HISTORIC AND DESIGN REVIEW COMMISSION

October 18, 2023

HDRC CASE NO: 2023-390
ADDRESS: 134 W KINGS HWY
LEGAL DESCRIPTION: NCB 3258 BLK 2 LOT W 83.5 FT OF 1
ZONING: R-5, H
CITY COUNCIL DIST.: 1
DISTRICT: Monte Vista Historic District
APPLICANT: Parker Dixon/DIXON PARKER & KATHERINE
OWNER: Parker Dixon/DIXON PARKER & KATHERINE
TYPE OF WORK: Driveway and curb cut modification
APPLICATION RECEIVED: September 22, 2023
60-DAY REVIEW: November 21, 2023
CASE MANAGER: Claudia Espinosa

The applicant is requesting a Certificate of Appropriateness for approval to replace the existing 16-foot wide driveway with a 20-foot wide concrete driveway with partial pervious surface.

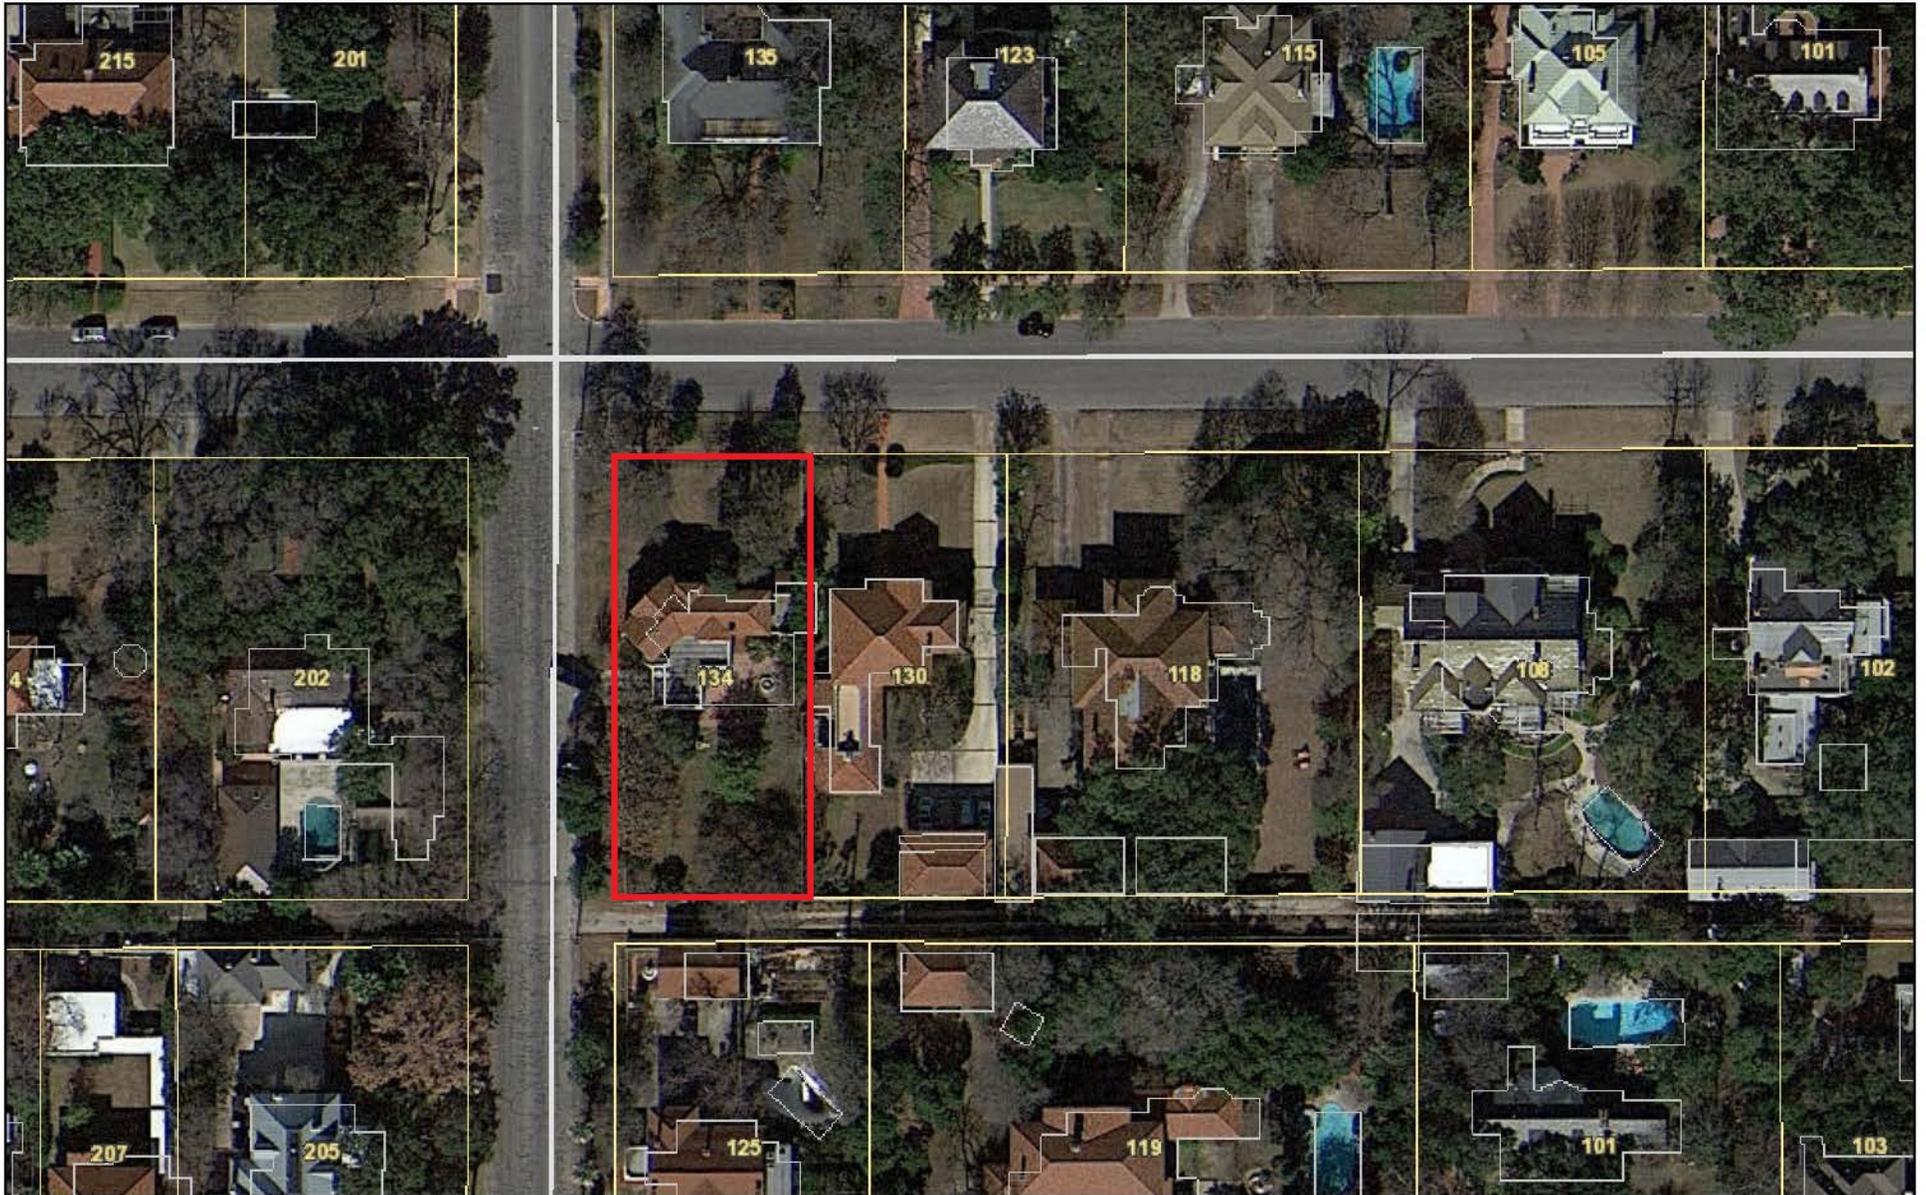
b. DRIVEWAY MODIFICATION – The applicant has proposed to widen the existing concrete driveway apron to twenty (20) feet to accommodate a double-width curb cut, apron, and driveway approach. According to Guideline 5.B.ii for Site Elements, the replacement of historic driveways should maintain the width and configuration of original curb cuts and applicants should avoid introducing new curb cuts where not historically found. This request to modify the existing driveway to 20-feet, is inconsistent with the guidelines and not commonly found within Monte Vista Historic District. Based on topography seen in the submitted photos, additional interventions such as retaining walls or curbing may also be required to retain the slopes evident on either side of the driveway.

Staff does not recommend approval to expand the existing driveway approach to twenty (20) feet based on finding b. Should the HDRC approve this request, staff recommends a stipulation requiring additional plan development to address the need for any retaining walls or additional curbing be submitted to staff for review prior to the issuance of a Certificate of Appropriateness.
